RE: EWO – Olympic Steel (S20A0480A)

Nucor Building Systems has completed an engineering analysis of existing Nucor job #S08A0480A. The EWO included investigating the impacts of updating the building code to IBC 2018. The follow loads are as follows:

**CROSS SECTION @ LINES 10-18**

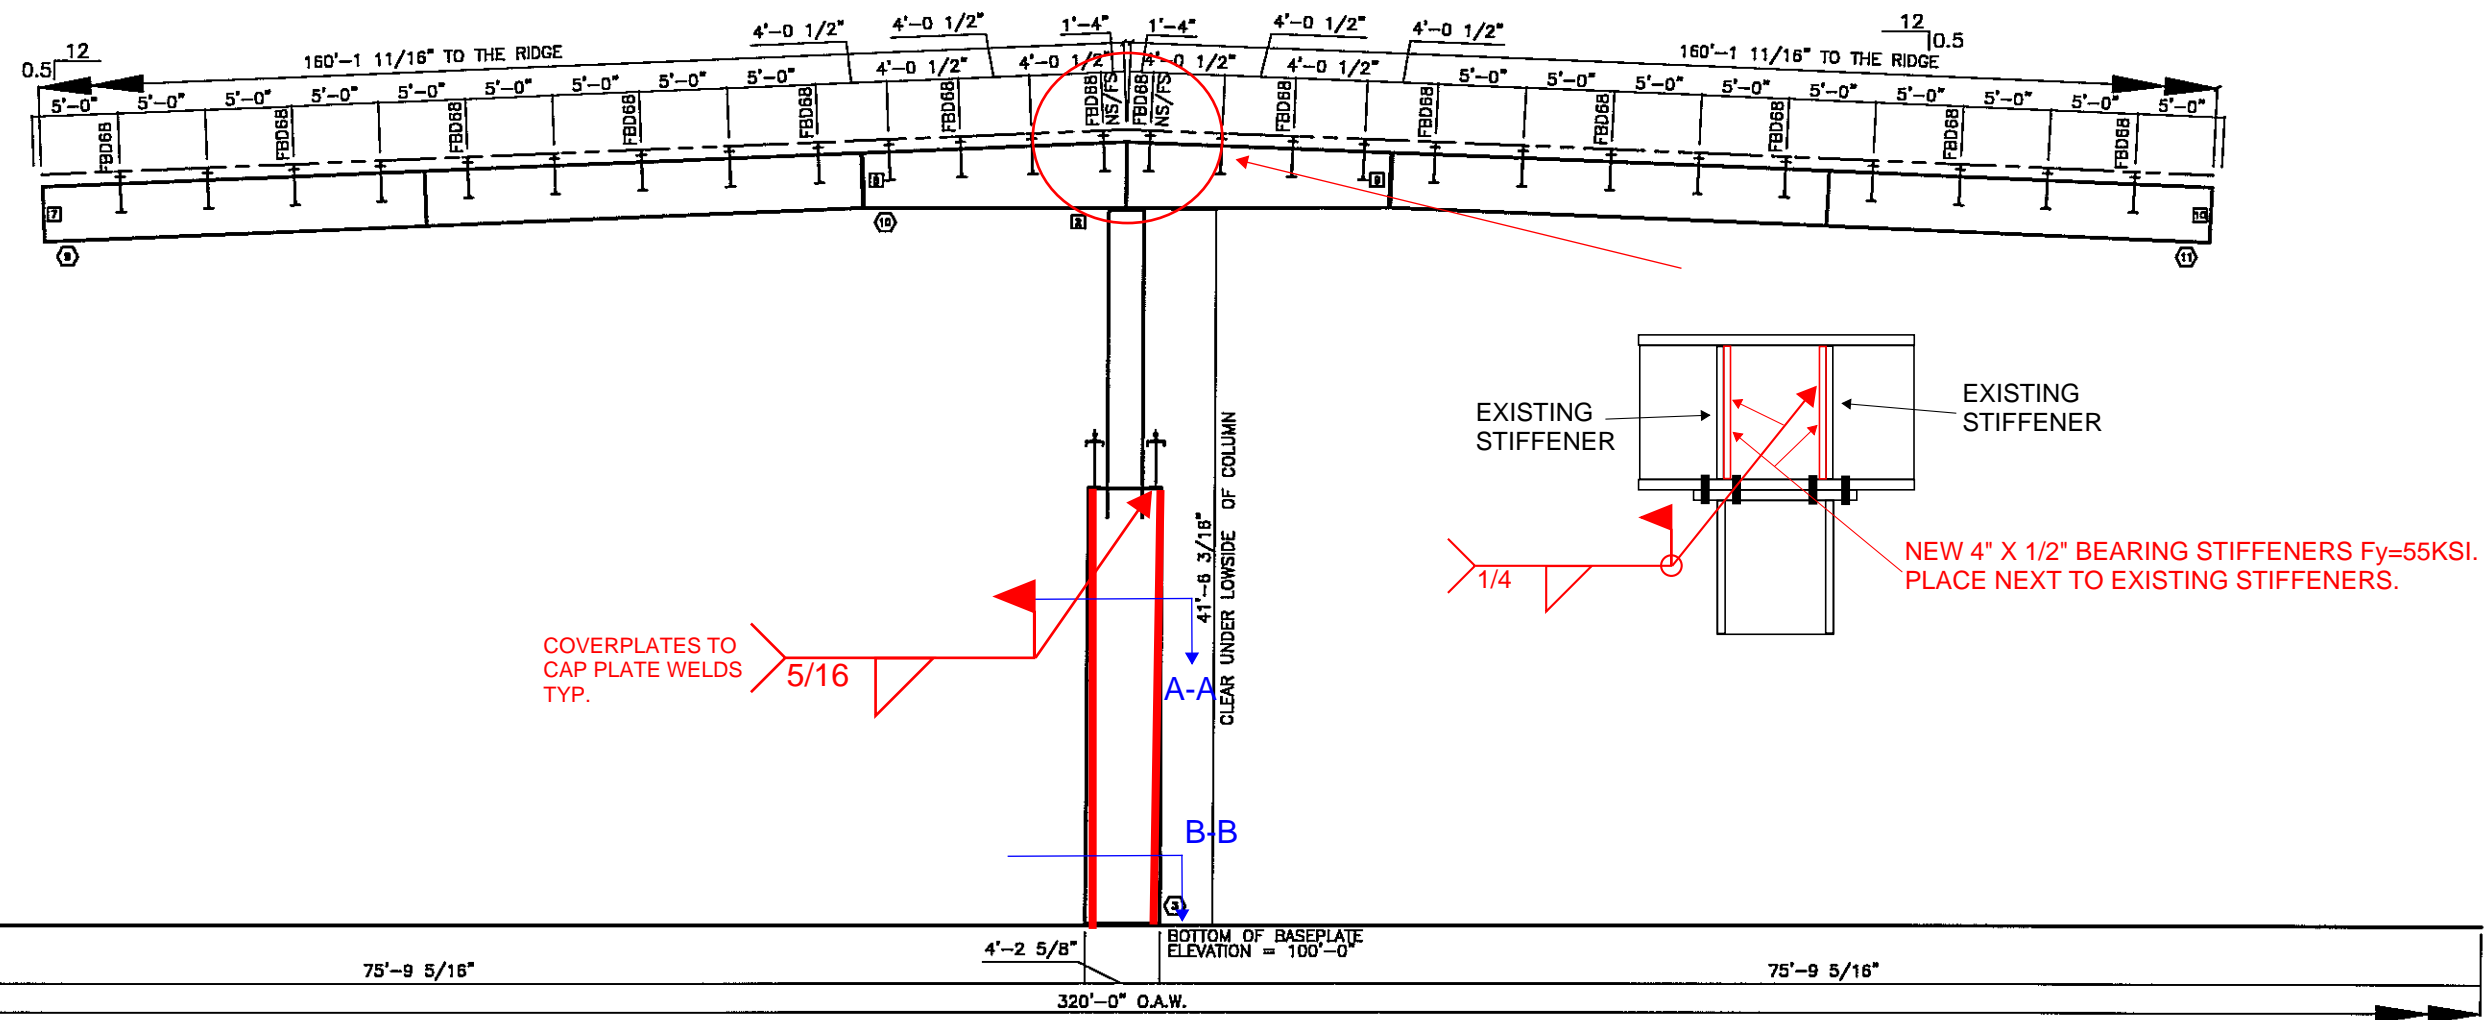
- 1) Frame lines 10-18 will require the following reinforcements:
  - a. The column flanges on lines E, J, and P will required cover plates.
  - b. The stiffeners in the fixed base connection will be field cut back to allow the cover plates to extend to the base plate.

- c. The moment connections above the columns on lines E, J, and P will require bearing stiffener reinforcements.
  - d. (2) Endplates per frame (10 total) will require bolt replacements.

**CROSS SECTION @ LINES 1&3**

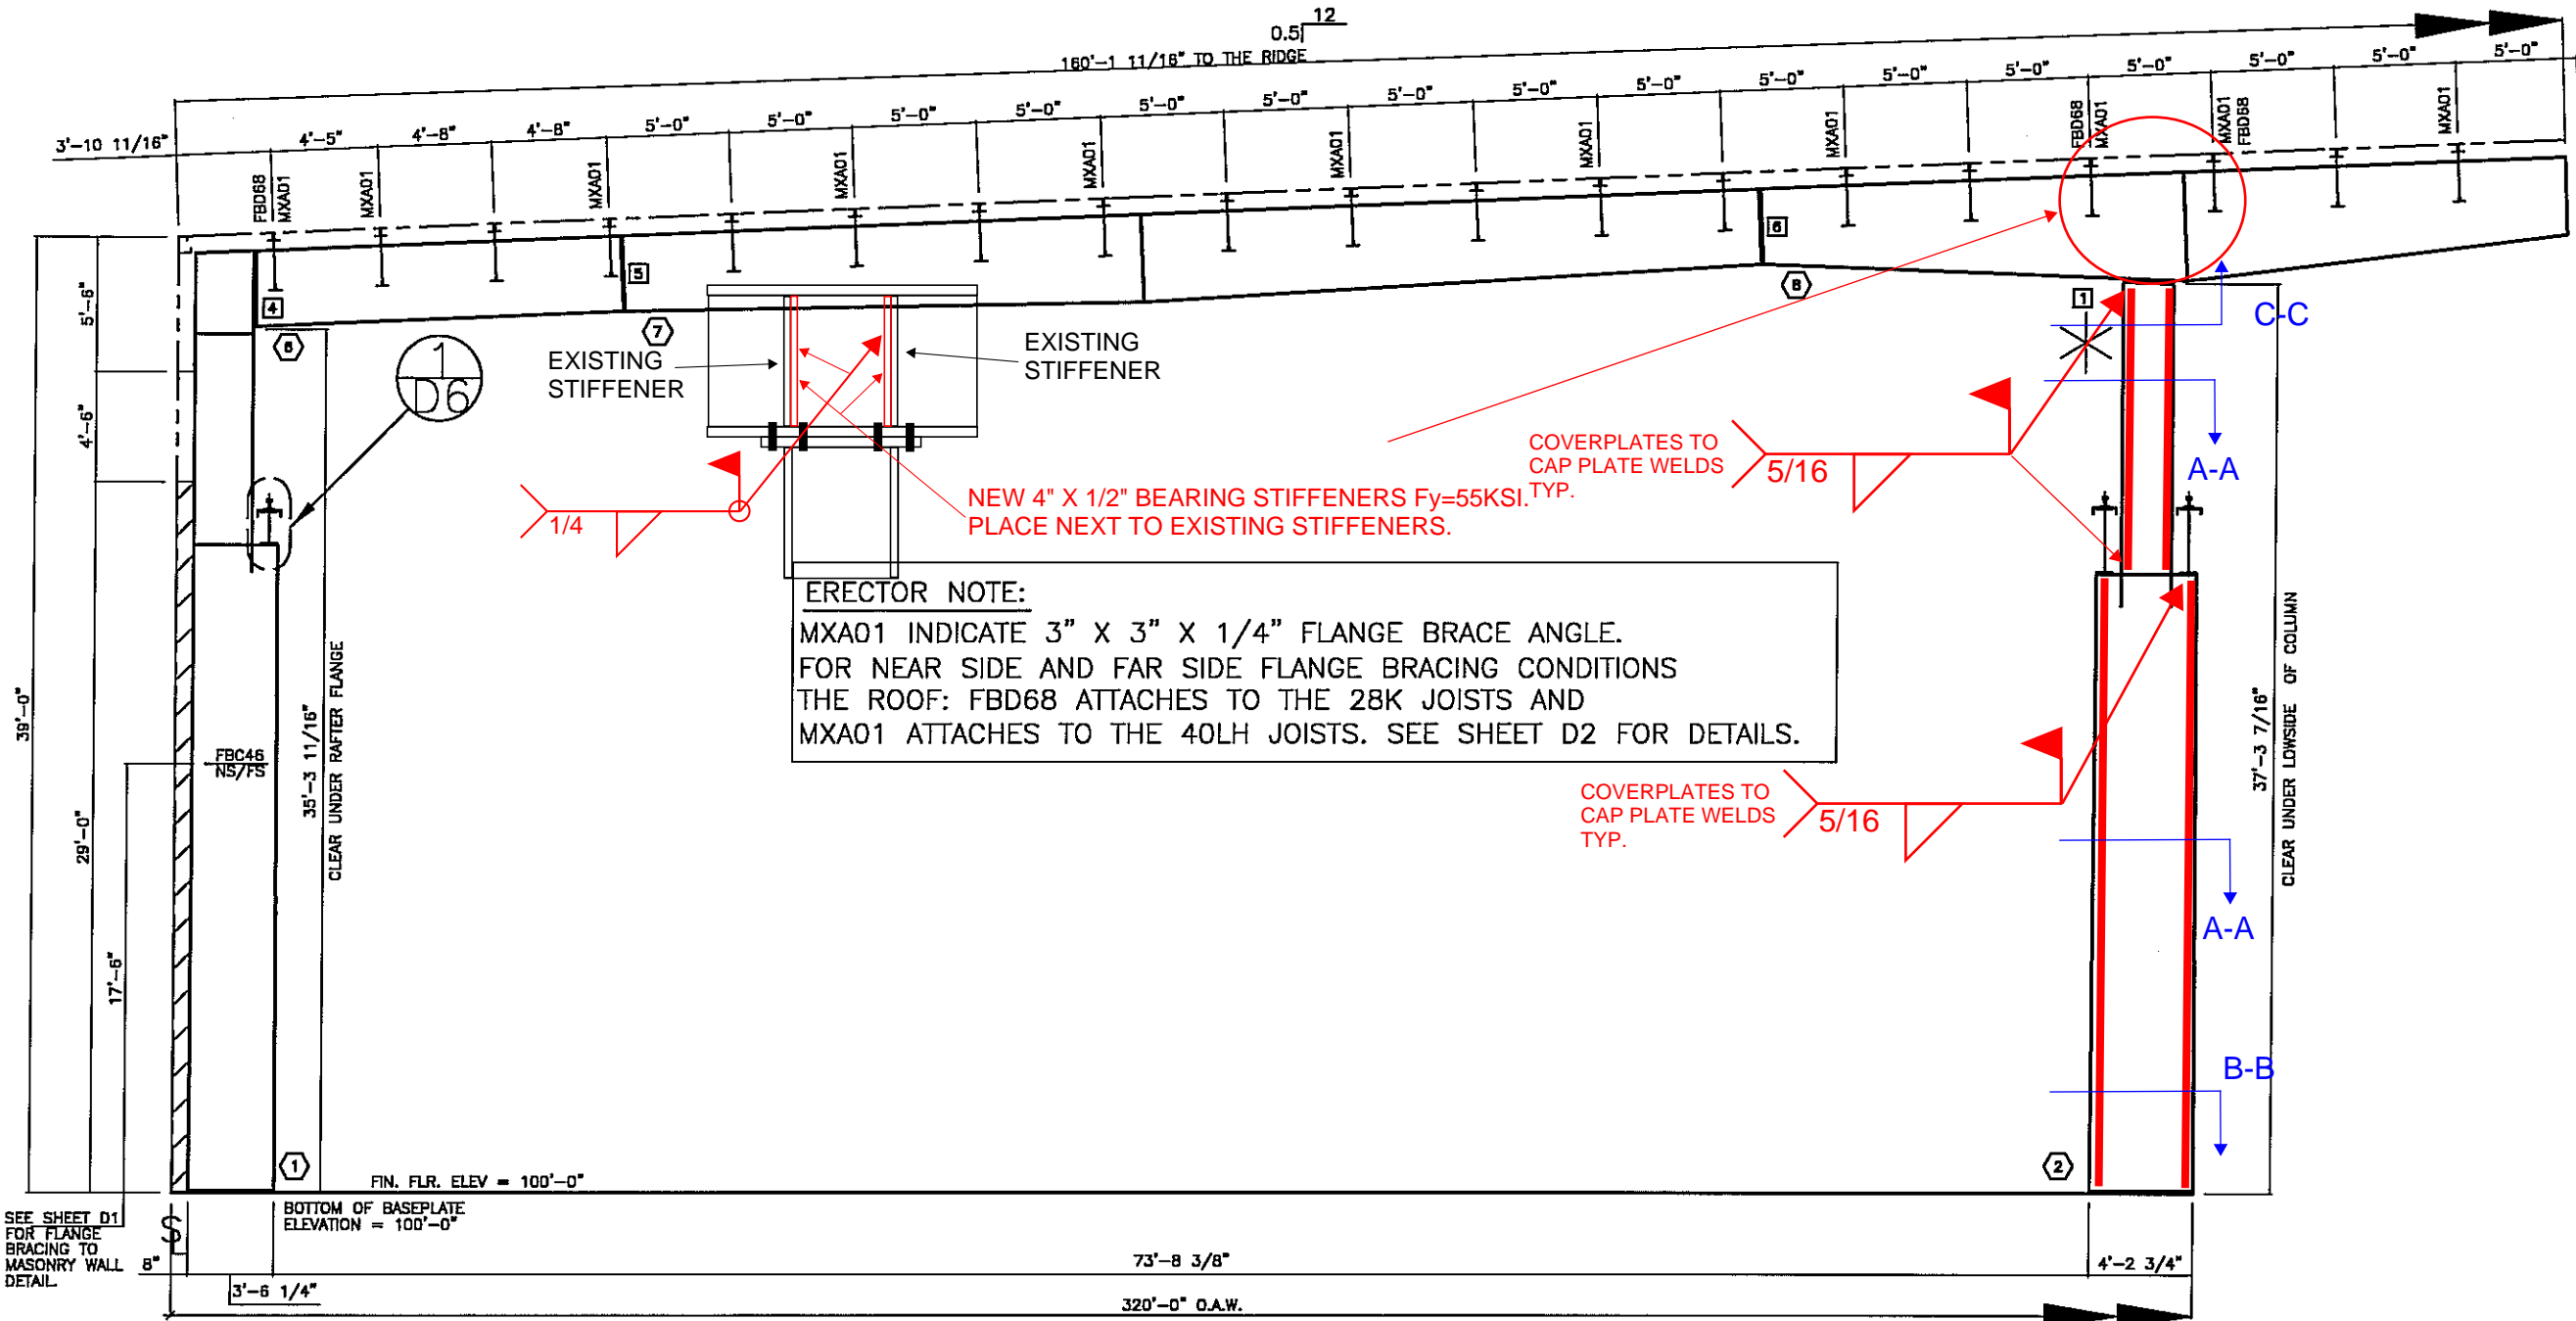
- e. See pages 3-5, and 10 for the fieldwork required.
- 2) Frame lines 1&3 will require the following reinforcements:
  - a. The column flanges on line N will required cover plates.

- b. The stiffeners in the fixed base connection will be field cut back to allow the cover plates to extend to the base plate.
  - c. See pages 6-7, and 10 for the field work required.

COVERPLATES TO CAP PLATE WELDS TYP. 5/16

**CROSS SECTION @ LINES 5 & 8**

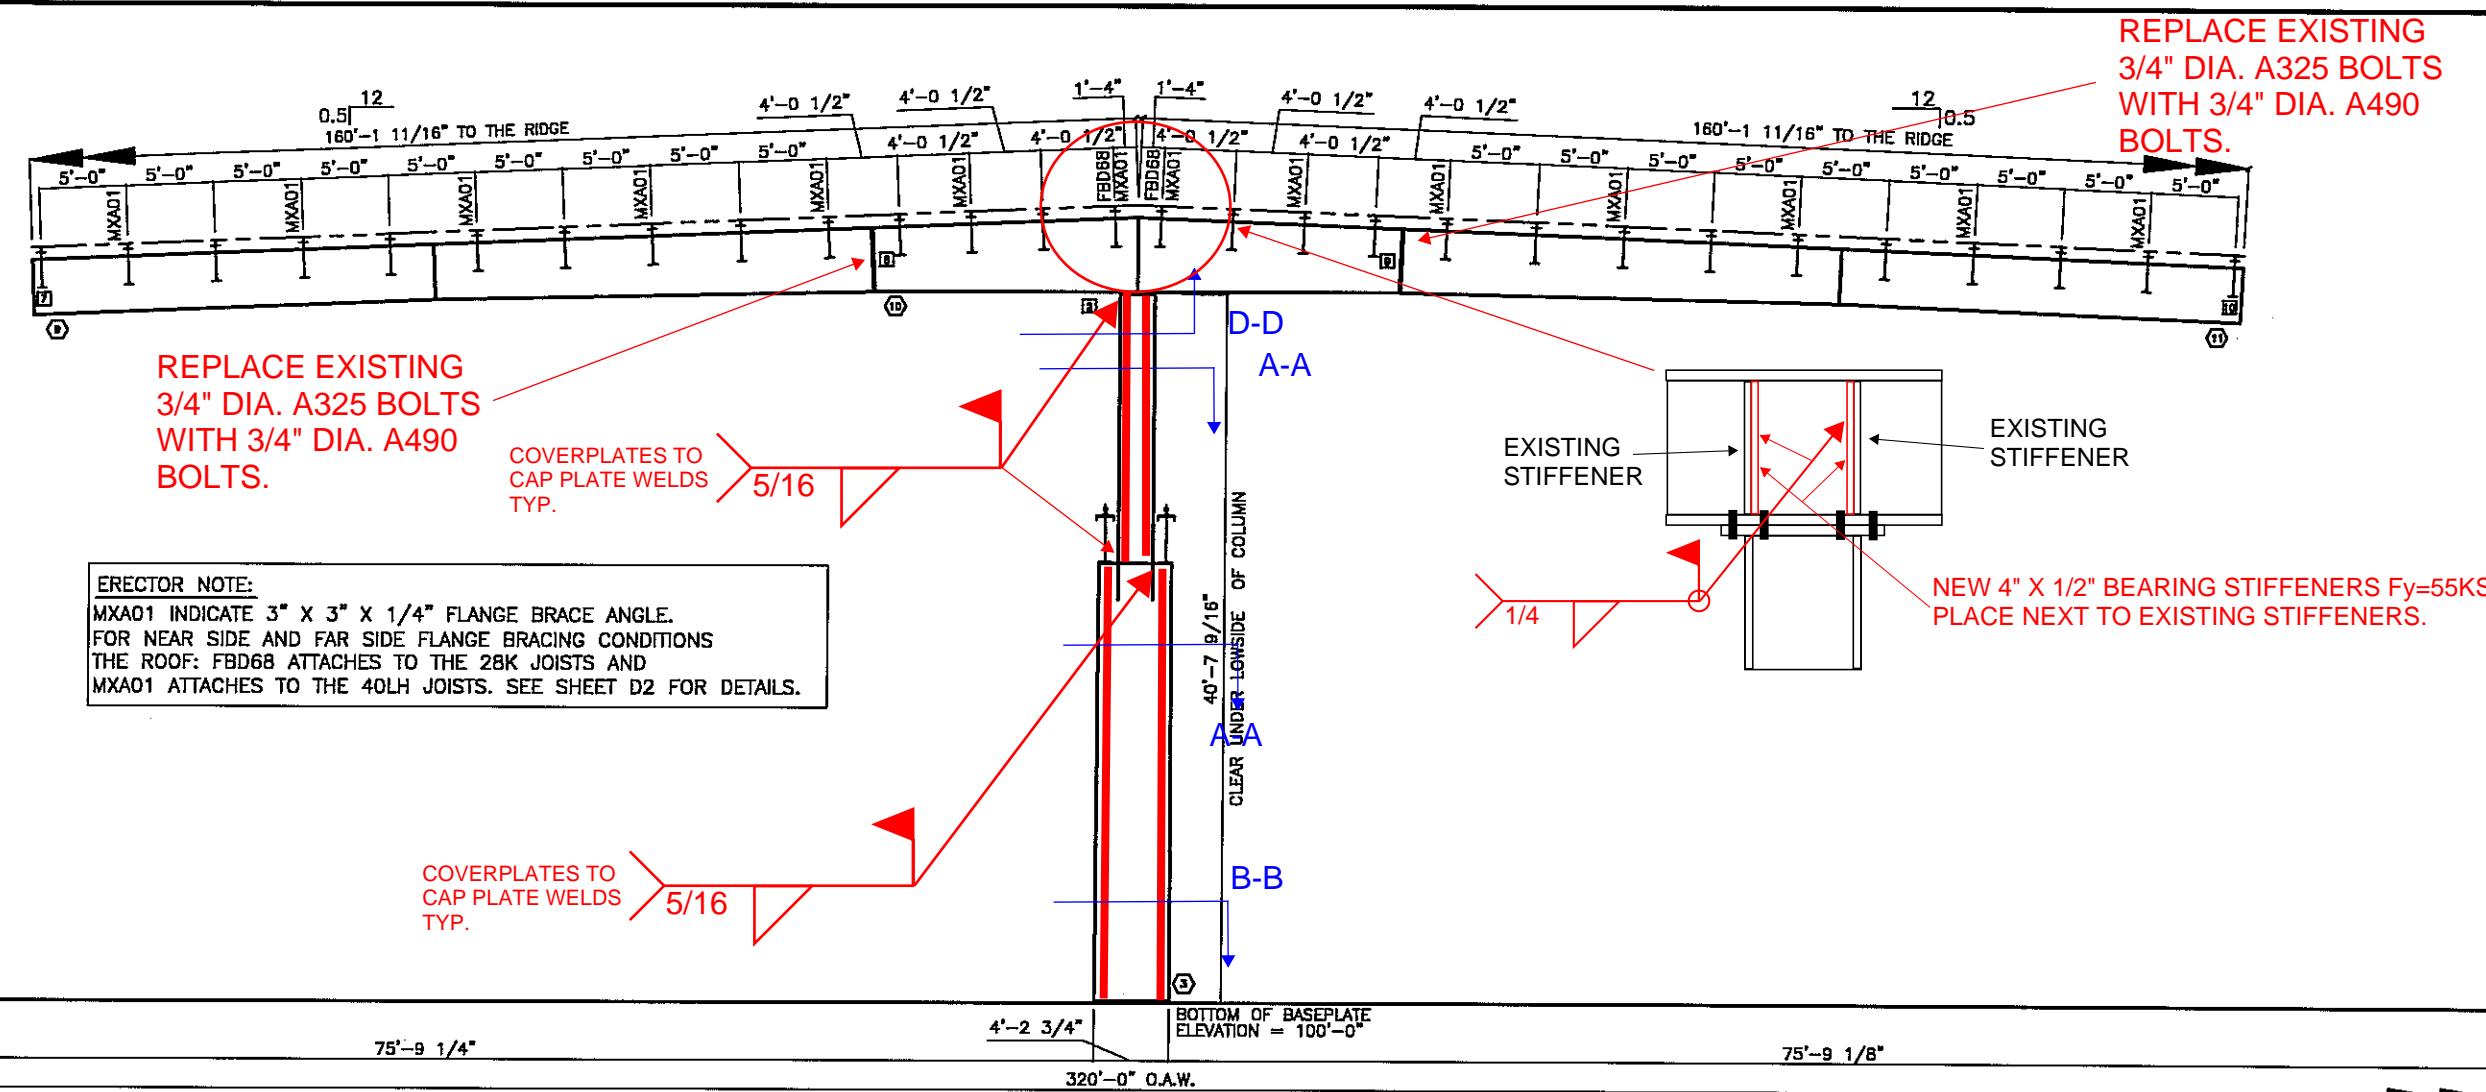
- 3) Frame lines 5-8 will require the following reinforcements:
  - a. The column flanges on lines E, J, and P will required cover plates.
  - b. The stiffeners in the fixed base connection will be field cut back to allow the cover plates to extend to the base plate.

- c. The moment connections above the columns on lines E, J, and P will require bearing stiffener reinforcements and additional holes will be field drilled into the connection for the attachment of additional bolts.
  - d. (2) Endplates per frame (10 total) will require bolt replacements.
  - e. See pages 8-10 for the fieldwork required.
- 4) A separate submittal from Vulcraft will be sent at a later date with the investigation results for the roof joist.
